August 19, 2011

RE: Peer Review Comments
343-351 Summer Street
Somerville, MA 02143

1.0 SUMMARY OF ENVIRONMENTAL DOCUMENTATION

BORING B-1A

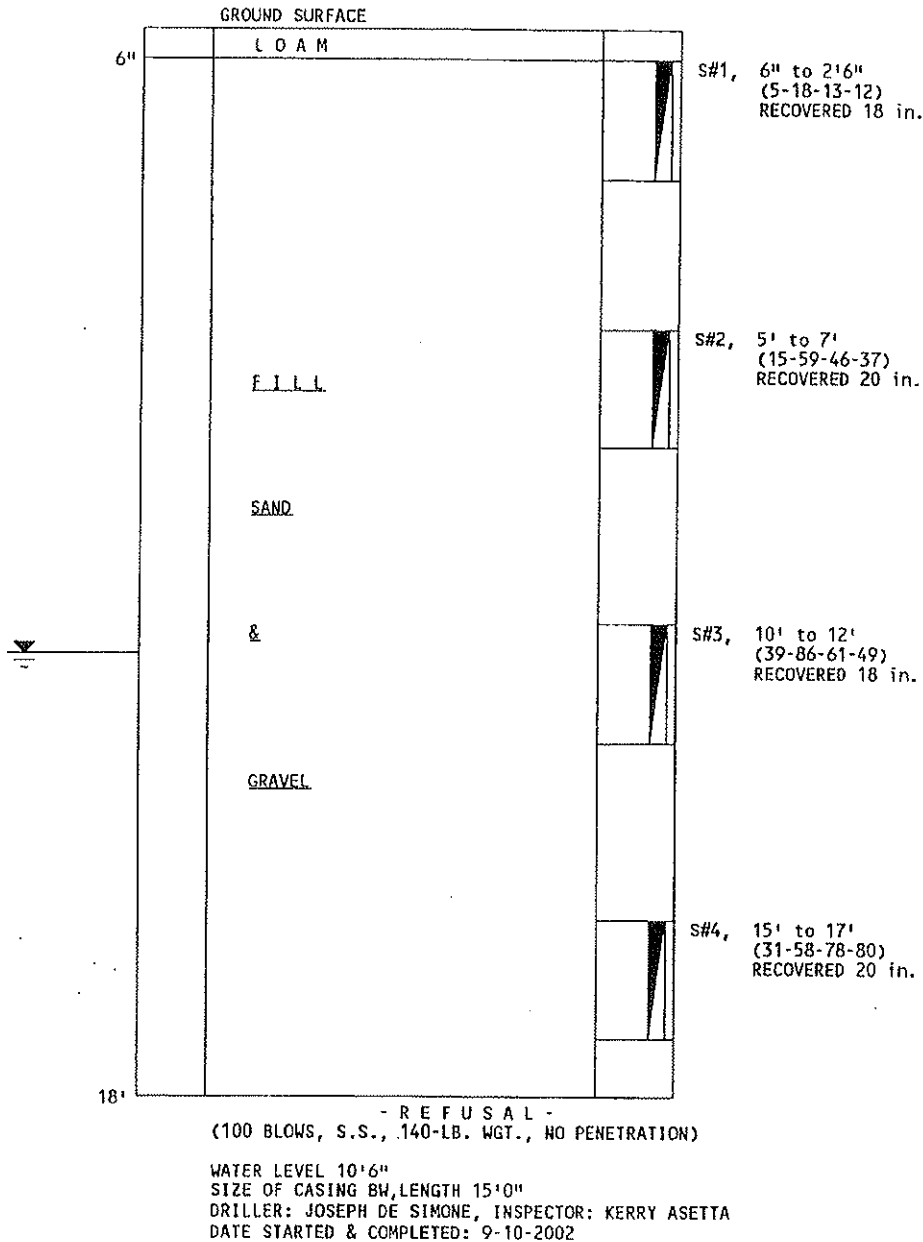
As described above, test borings having common number designations were reportedly placed in close proximity to each other to achieve the required depths of boring advancement. A review of available boring logs reveal a wide variation in both depths of fill and static water elevations recorded between what has been expressed as being nearby. Specifically, a review of the log for test boring B-1 reveals that groundwater was encountered within a stiff blue clay formation at 15 feet from grade, with approximately five (5) feet of fill present at this location. Conversely, groundwater was encountered at 10 feet from grade during the advancement of B-

1A, within a fill unit that extended over the entire length of the bore hole (18 feet). Similarly, a five (5) foot difference in depths to groundwater was encountered during the advancement of B-4 and B-4A. This variation in site stratigraphy and depths to groundwater also supports the recommendation for further evaluation of site hydrology.

BORING B-6

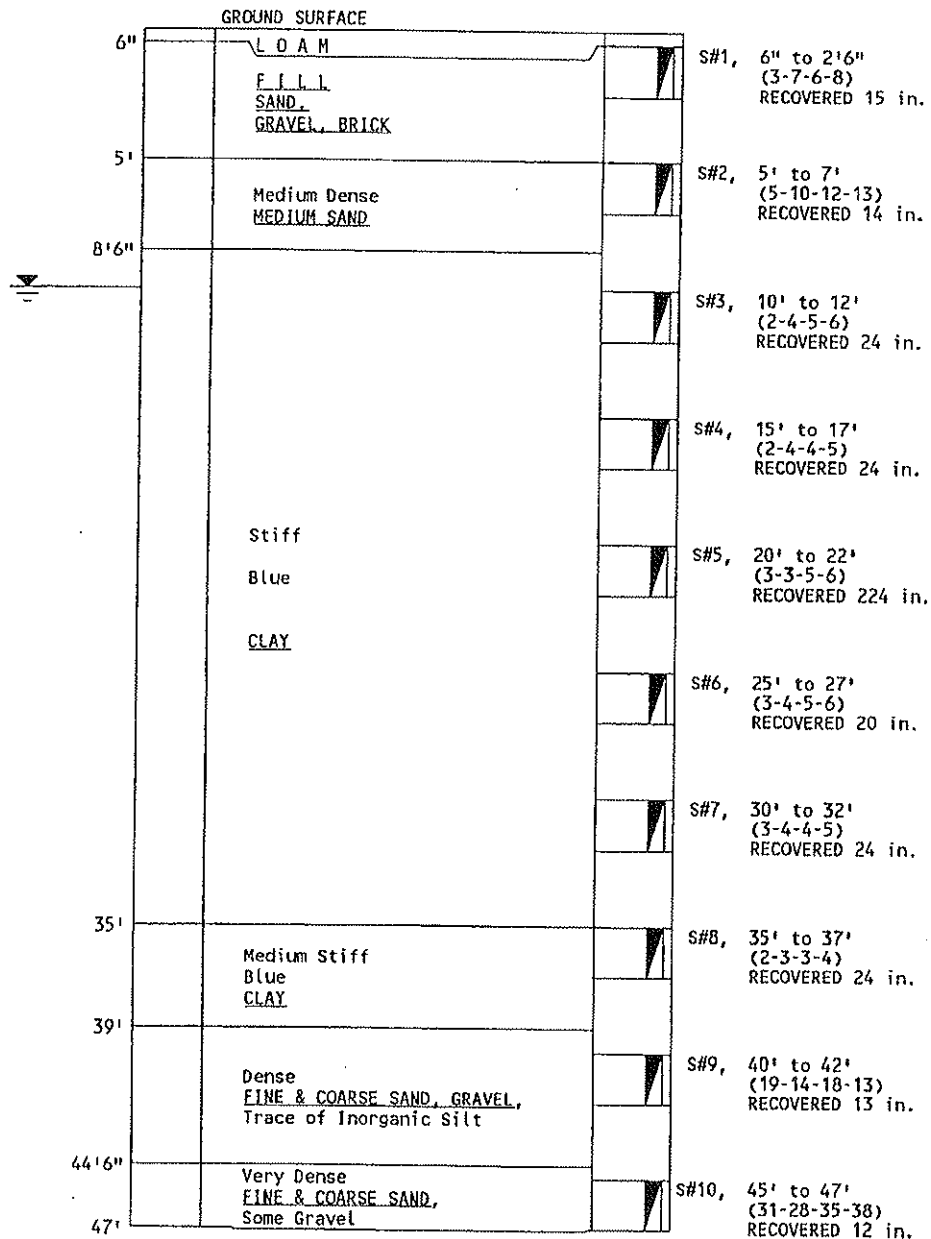
From a review of Attachment B, it is seen that a fill layer generally ranging between 5 (B-4, B-5) to 18 feet from surface grade (B-1A) extends across 343-349 Summer Street. This fill unit is characterized as being comprised of sands, concrete, asphalt and/or brick and was underlain by medium sands, followed by native yellow and blue clays. A variable sand layer was identified between 15-18 feet at B-3 and refusal atop probable bedrock was reported at 36 feet from surface grade at B-4A. Split-spoon refusal was also encountered at varying depth intervals, alluding to the heterogeneity of the fill unit. B-6 was also advanced to 47 feet; however, the location of this test boring is unknown.

2. The locations of test borings B1A, B2A, B2B, B4A and B6, which were installed in September of 2002: Boring B1A was attempted in the area of B-1; B2A and B2B were attempted in the area of B-2; B4A was attempted in the area of B-4. These borings encountered refusal prior to being able to install monitoring wells and therefore, were not utilized by IES, but instead additional attempts in their vicinity (i.e. B-1, B-2, and B-4) were utilized as part of the investigation. With regard to B-6, based on the depth of the boring (47 feet), the fact that a monitoring well was not installed, and the fact that the drilling contractor was hired separately (i.e. not by IES), this boring may have been advanced for structural purposes (or some other purpose beyond IES's investigation), and as such was not used in the environmental assessment by IES.
